REPORT ON

INSTALLATION OF EXTRACTION WELL EW-13 FOR
ON-SITE GROUNDWATER EXTRACTION SYSTEM
2221 NIAGARA FALLS BOULEVARD
WHEATFIELD, NEW YORK

Design Clarifications/Modifications

VAULT CONTROL PANEL
NO SCALE

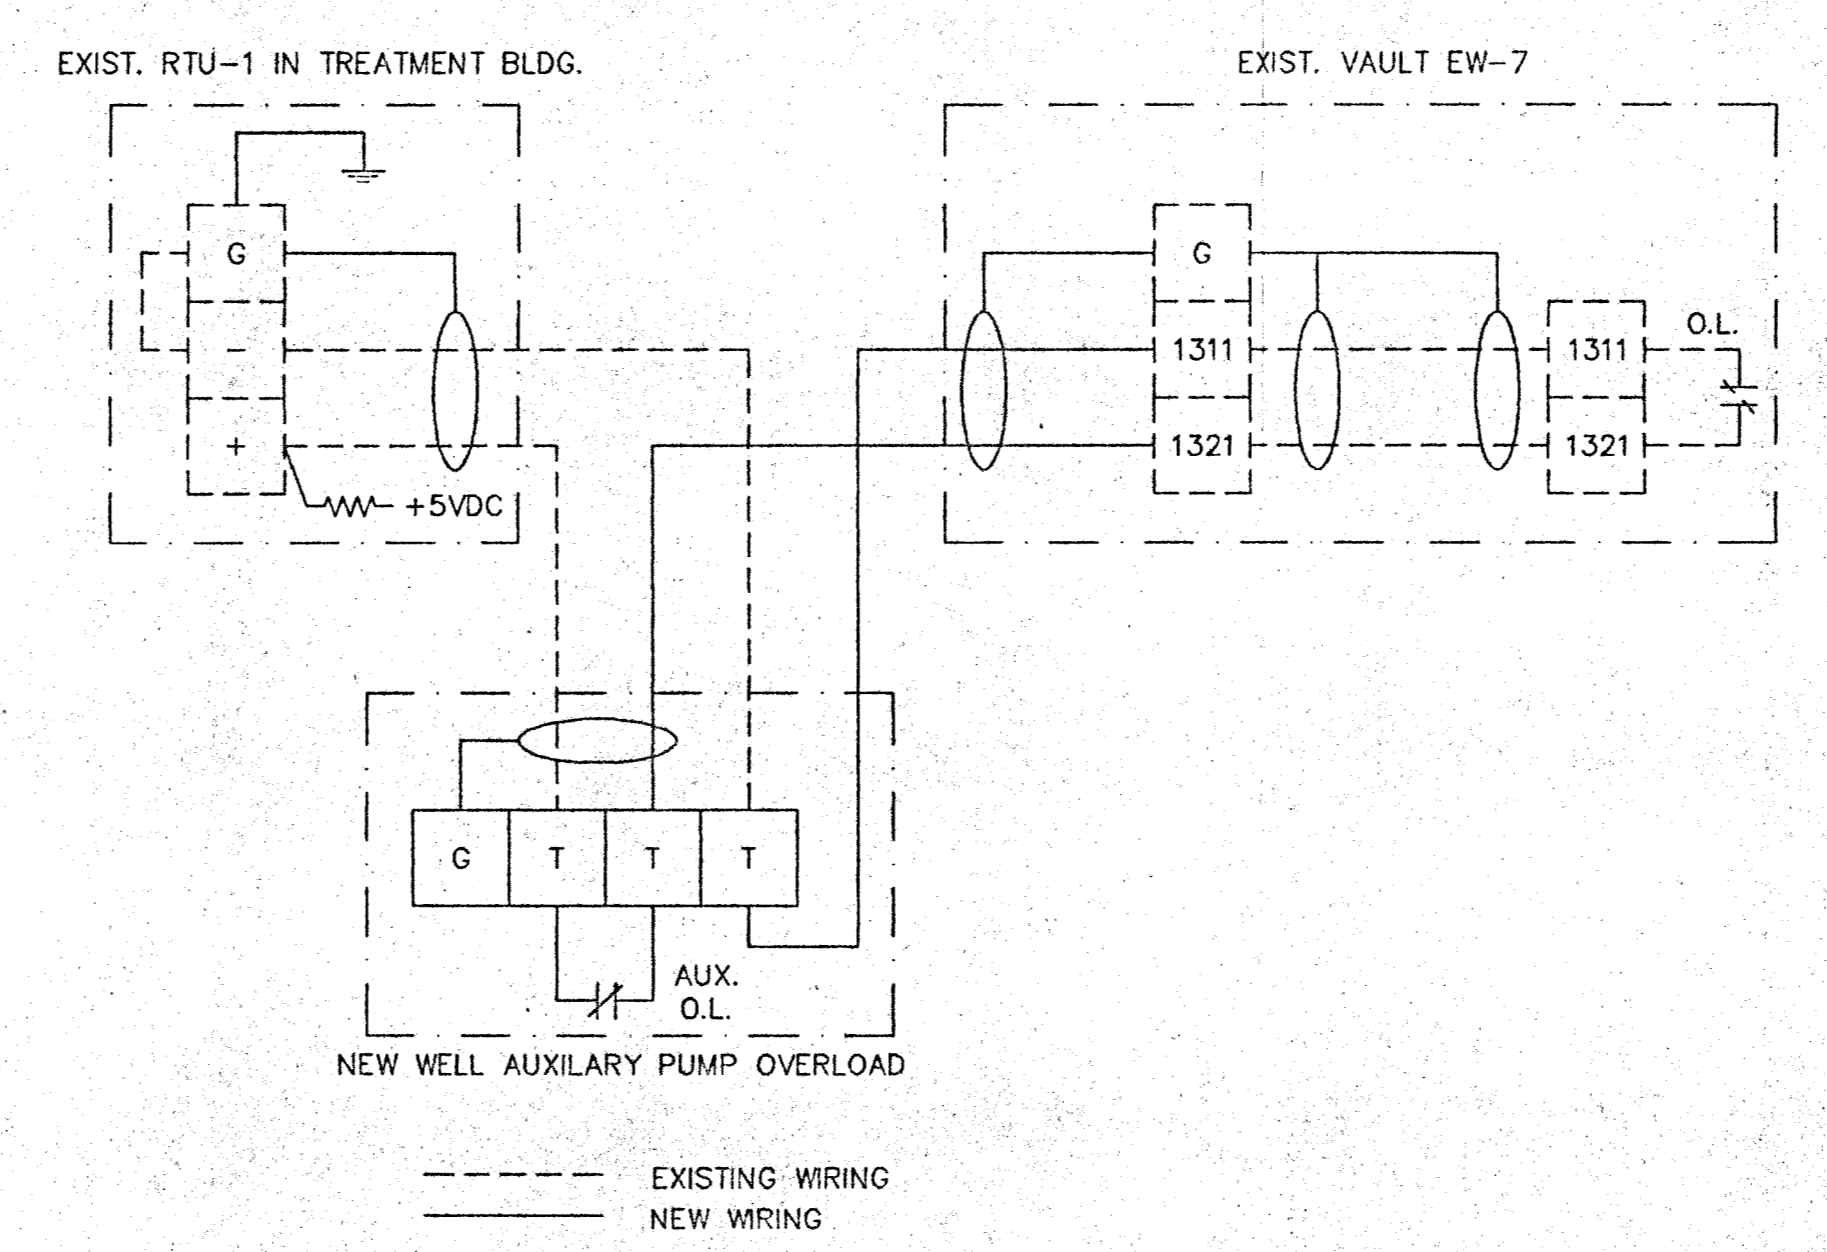
LOCATION / REFERENCE OF MODIFICATION: Drawing E-2

MODIFICATION MADE: Warrick controller specified, No. 2D1F4-2Z1, is incorrect; correct catalog number is 2G1F4-2Z1

TYPE 75 BUTTERFLY VALVES LEVER

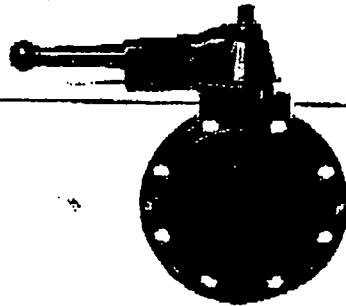
*TO BE GEAR
OPERATED, NOT
LEVER OPERATED
AS SHOWN
Q10*
